ORDINARY AGENDA

Tuesday 10 September 2019

Planning Application: PA\20\0001

It is recommended that the application for Use and Development for Multiple Dwellings (8 units), on land located at 9 East Westbury Place, Deloraine (CT: 125324/1), by MJ Architecture, be APPROVED, generally in accordance with the endorsed plans:

Figure 5: sight lines for pedestrian safety from driveways (AS2890.1.2004)

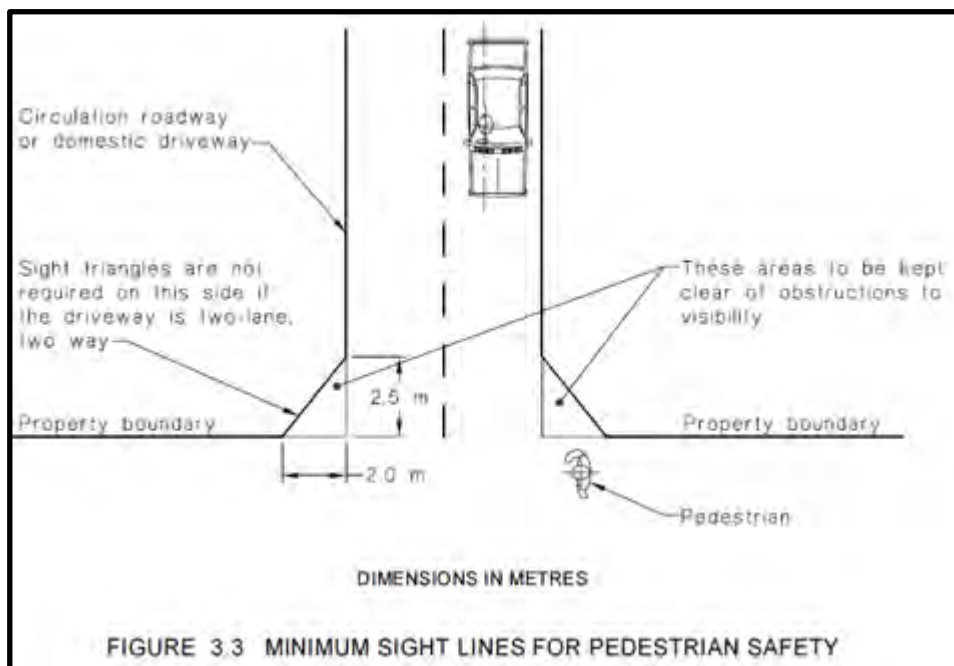
An amended site plan is to be submitted to the satisfaction of Council's Town Planner showing a pedestrian sight splay being provided for at the exit as required by AS2890.1:2004.

DRAWING		
SITE PLAN		
PROJECT No.	DATE	DRAWING No.
1819	19/7/19	01.03
	REVISION C

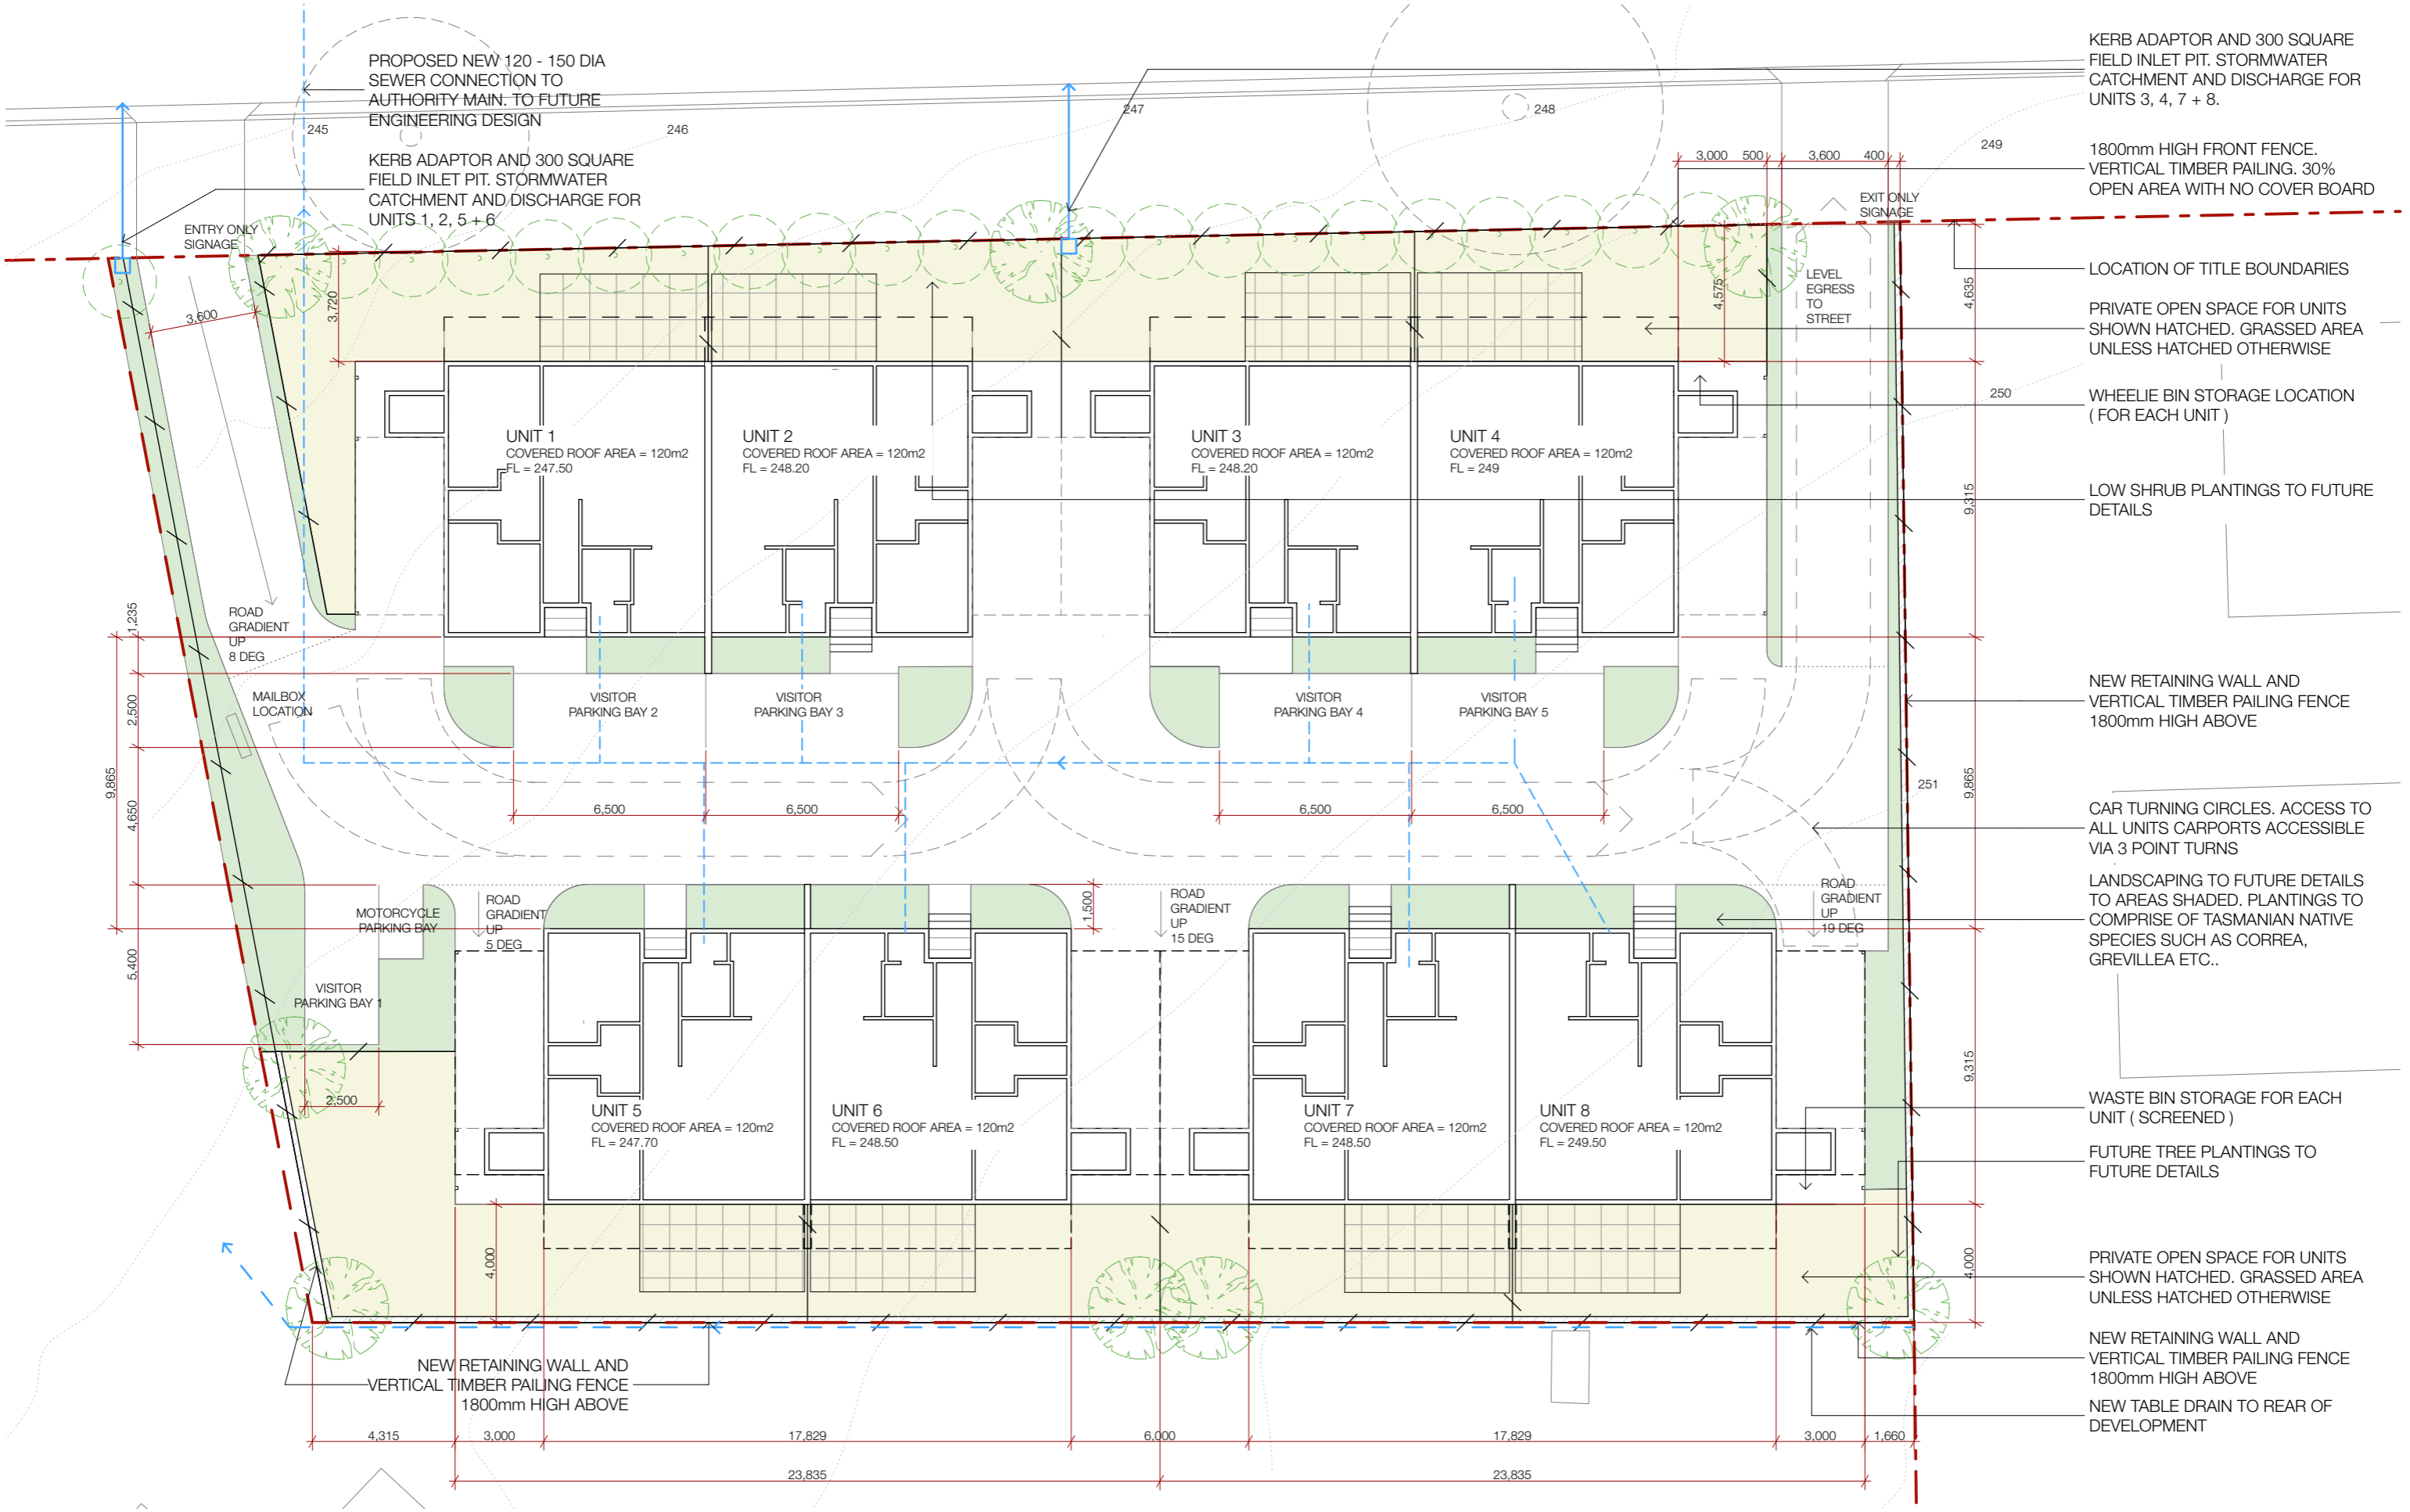
It is also proposed to reverse the direction of traffic by swapping the location of the entry and exit. As such, this will mean that the entry and exit need to be adequately signposted and the direction of travel be painted on the asphalt to ensure that the vehicle movement is in the correct direction.

An amended site plan must be submitted showing the entry to the development at the southern crossover and the exit at the northern crossover. The entry and exit are to be appropriately sign posted and line marked clearly showing the direction of travel.

An amended site plan must be submitted to Council showing a pedestrian access gate, including height and design details, along the frontage for units 1, 2, 3 & 4, to the satisfaction of Council's Town Planner.

- 1) Long sections of the internal driveway have been more clearly represented on the attached revised elevations. Please refer to drawings 2/D02.01, 1/D02.02, 2/D02.02 and 3/D02.02, dated 18/07/19. Additionally road gradients have been confirmed and noted on the site plan drawing D01.03, dated 18.07.19.

Site retaining walls have been more clearly defined on the site plan drawing D01.03

- 3) An amended TIA is attached reflecting a 3.6m driveway width. The site plan has also been amended to reflect this
- 4) An amended TIA is attached reflecting the need to entry and exit only signage. The site plan has also been amended to reflect this
- 5) Parallel parking bays have been extended in length to 6.5m. However it is noted that AS 2890.1 allows for a parking bay length of 5.9m and 6.2m (where obstructed) and when the driveway width is 3.6m. I have attached an excerpt copy for reference
